## DOOR QUESTIONS:

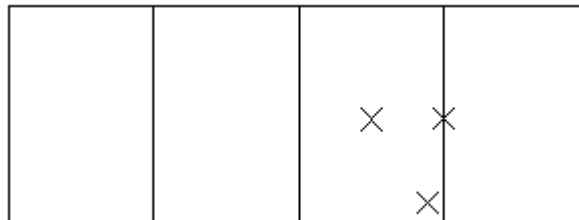
**DO1: (Q13:) How many panels for sliding glass doors are required to be tested?**

A: If you want your approval to read "Approved for 3 panels or less", then test 3 panels and if testing for impact, aim the projectile where specified below.

If you want your approval to read "Approved for 4 panels or more", then test 4 panels, and if testing for impact, aim the projectile where specified below.

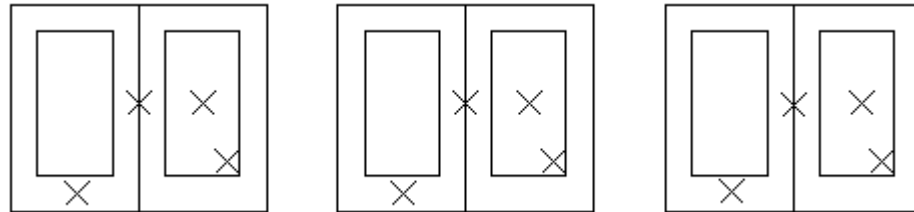
**DO8: (Q73:) Where do double swinging glazed doors have to be impacted?**

A: For double swinging glazed doors the following impact diagram applies.

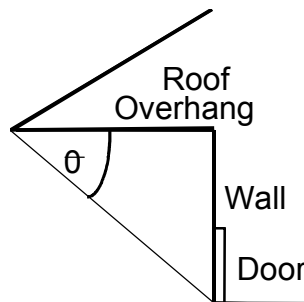
**DO9: (Q80:) Is the water test required for entrance doors that have flat sills?**

A: The water test on this particular product is only required when the roof's overhang is shorter than the height of the wall where the door is located. (If angle theta is greater than 45° then the water test is required on doors with flat sills.) This also applies to residential applications.
